* AMENDED
PLAN OF PROPOSED
SEPTIC SYSTEM

LOCUS: LOT 8 GOSS ROAD
NORTH HAMPTON, NH

APPLICANT: ANNE W. BIALOBRZESKI
247 LANDING ROAD
HAMPTON, N.H. 03842
DESIGNER PERMIT #348
*AMENDED 4/30/91 TO ADD BM #3 & 4 AND TIES

CROSS SECTION — NO SCALE

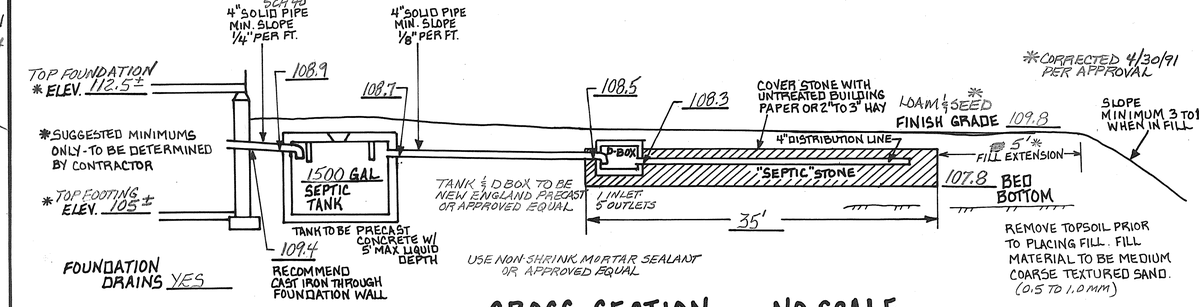
4" SOLID PIPE SCH 40 MIN. SLOPE 1/4" PER FT.
4" SOLID PIPE MIN. SLOPE 1/8" PER FT.
TOP FOUNDATION * ELEV. 112.5±
108.9
108.7
108.5
108.3
COVER STONE WITH UNTREATED BUILDING PAPER OR 2" TO 3" HAY
LOAM & SEED
FINISH GRADE 109.8
*CORRECTED 4/30/91 PER APPROVAL
SLOPE MINIMUM 3 TO 1 WHEN IN FILL
*SUGGESTED MINIMUMS ONLY - TO BE DETERMINED BY CONTRACTOR
* TOP FOOTING ELEV. 105±
1500 GAL SEPTIC TANK
TANK TO BE PRECAST CONCRETE W/ 5' MAX LIQUID DEPTH
D-BOX
4" DISTRIBUTION LINE
"SEPTIC" STONE
5' FILL EXTENSION
107.8 BED BOTTOM
TANK & D BOX TO BE NEW ENGLAND PRECAST OR APPROVED EQUAL
1 INLET 5 OUTLETS
35'
REMOVE TOPSOIL PRIOR TO PLACING FILL. FILL MATERIAL TO BE MEDIUM COARSE TEXTURED SAND. (0.5 TO 1.0 MM)
FOUNDATION DRAINS YES
109.4
RECOMMEND CAST IRON THROUGH FOUNDATION WALL
USE NON-SHRINK MORTAR SEALANT OR APPROVED EQUAL
